# **ENCLOSURE 2**

### **CHANGES TO LICENSE APPLICATION CHAPTER 1**

# **TRISO-X Fuel Fabrication Facility**

<b>Revision</b>	<b>: 2</b>
<b>Status</b>	<b>: Approved</b>
<b>Project</b>	<b>: Fuel</b>
<b>NRC Docket No.</b>	<b>: 70-7027</b>

Figure 1-3: Plan View of Geologic Cross Sections

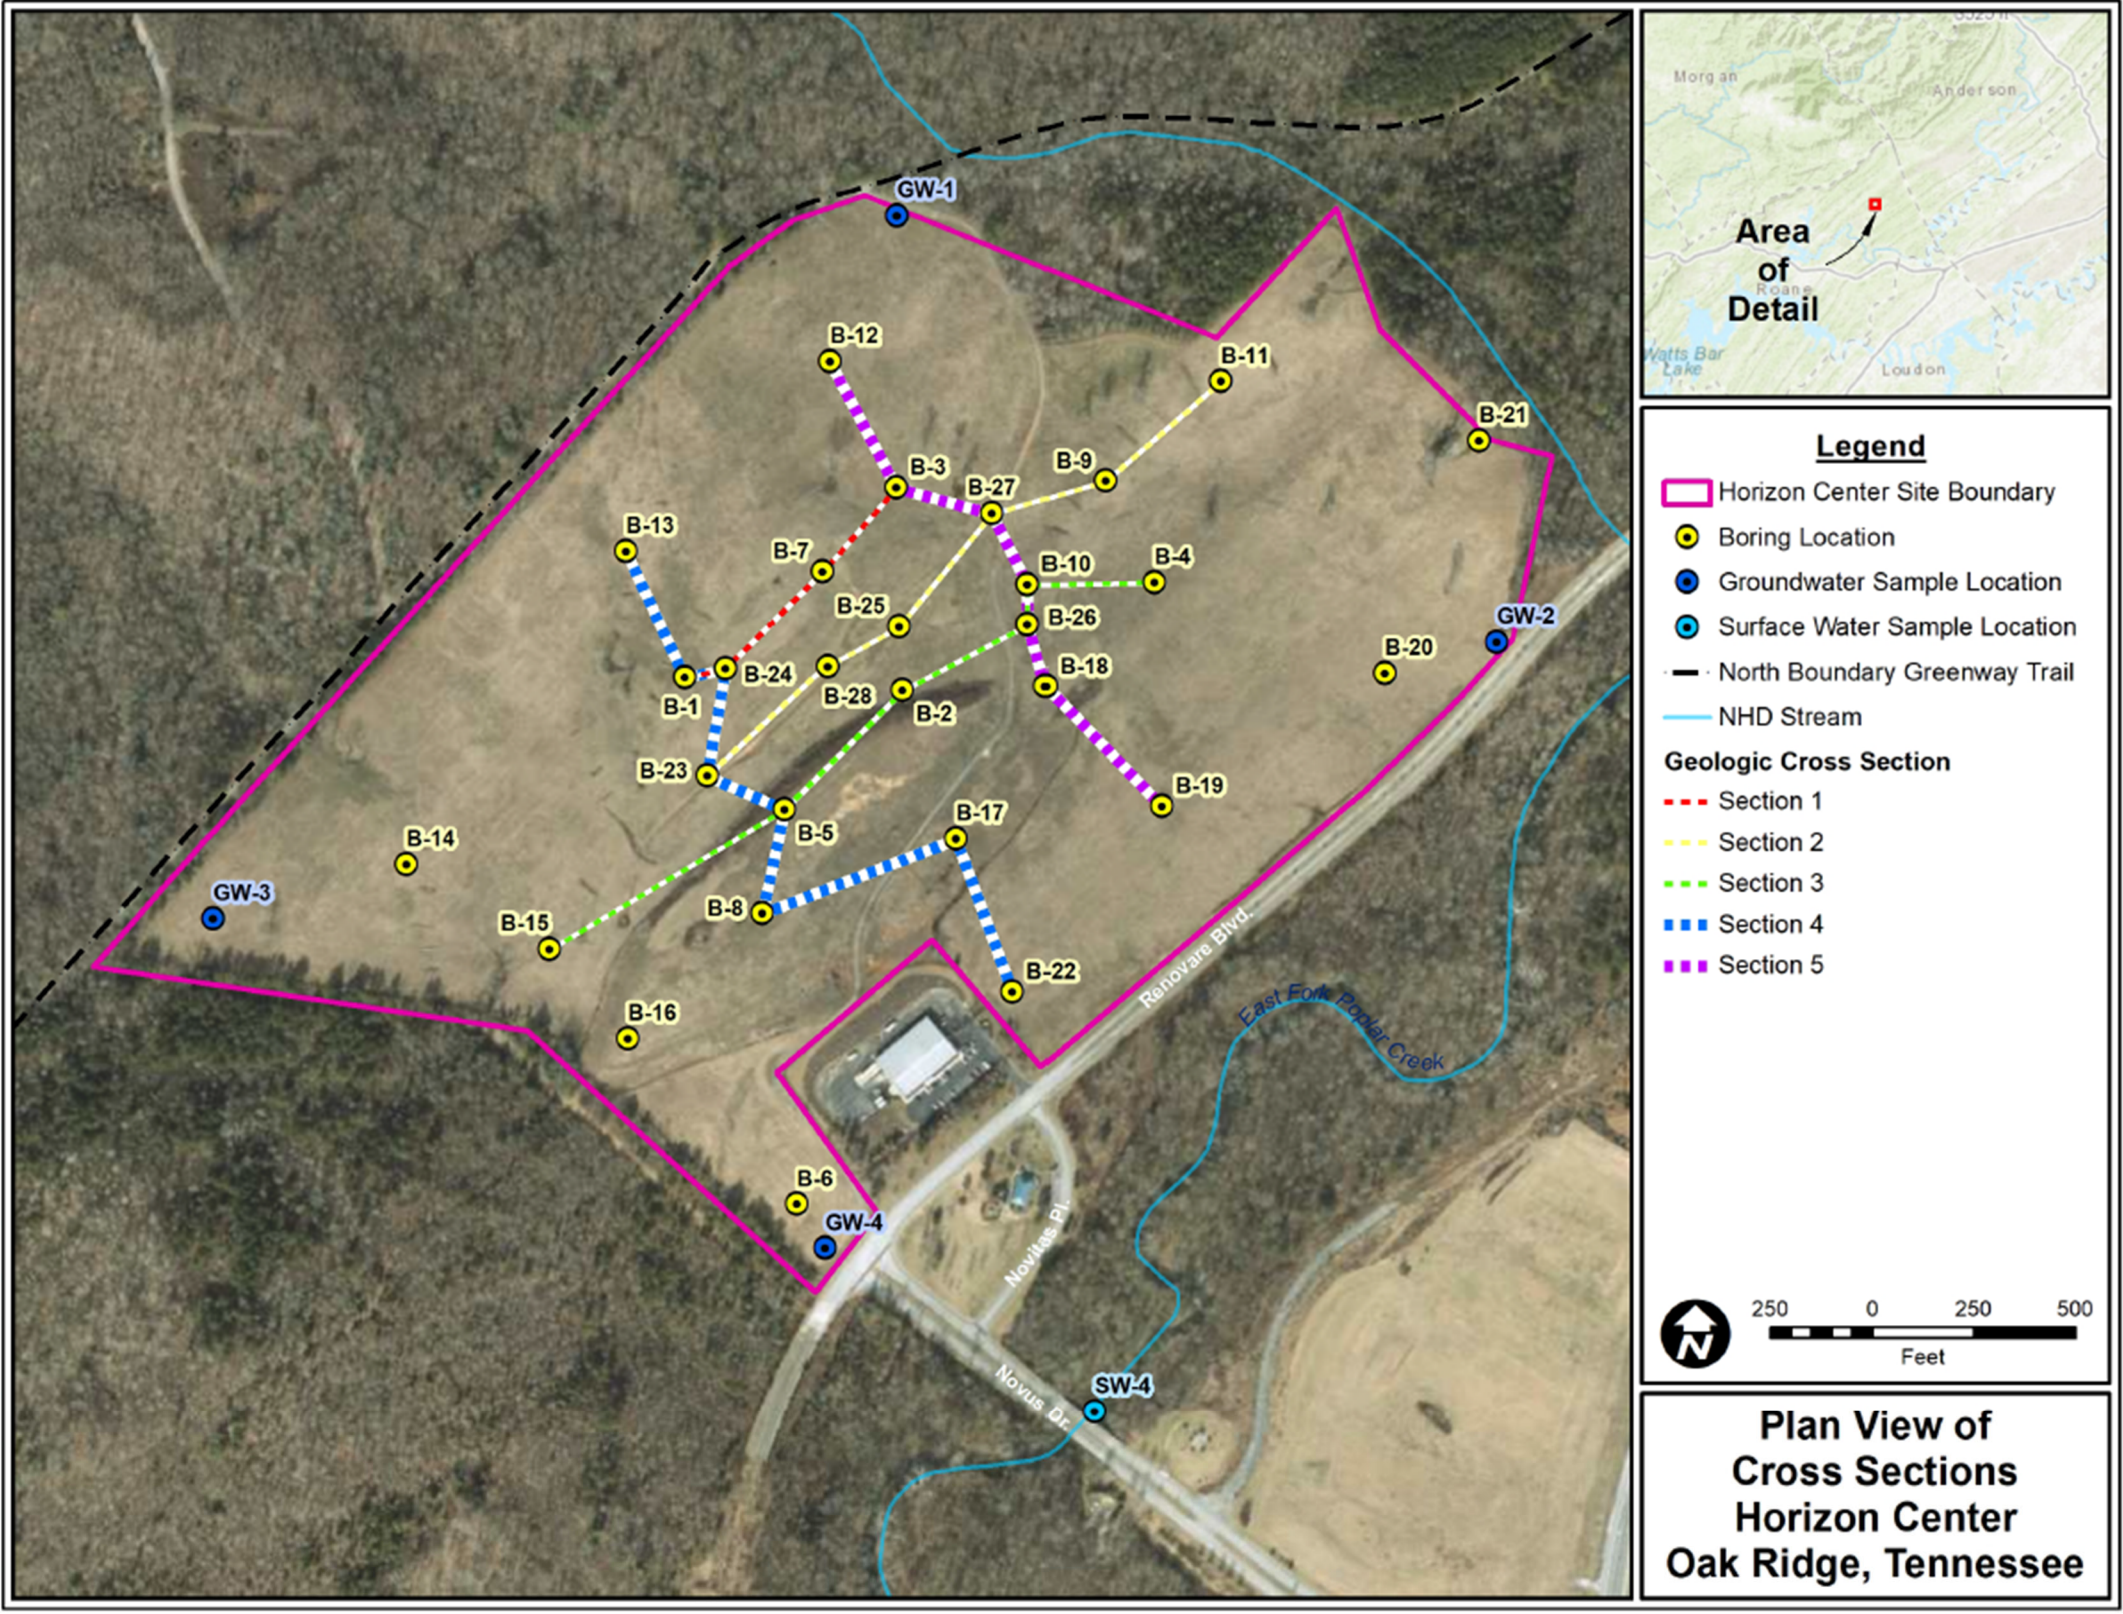
Revision	Date	Section/Page	Description of Change
1	5-Apr-22	ALL	Initial issue.
2	4-Nov-22	N/A	All changes for this revision are based on RSI responses (ML22286A144).
		Section 1.1.1	Added geotechnical discussion of site regarding slope stability, soil liquefaction, differential settlement, bearing capacity, karst features, and site cross sections.
		Section 1.1.2	Added design basis values for seismic, wind, precipitation, hydrological, and geological NPH.
		Section 1.3	Separated special exemptions and special authorizations. Re-numbered subsections.
		Section 1.3.1.1	Added detail for criticality monitoring exemption.
		Figures 1-3 thru 1-8	Added new figures for site geological cross sections.

The cross sections of subsurface soil/rock profiles are provided in Figures 1-3 through 1-8.
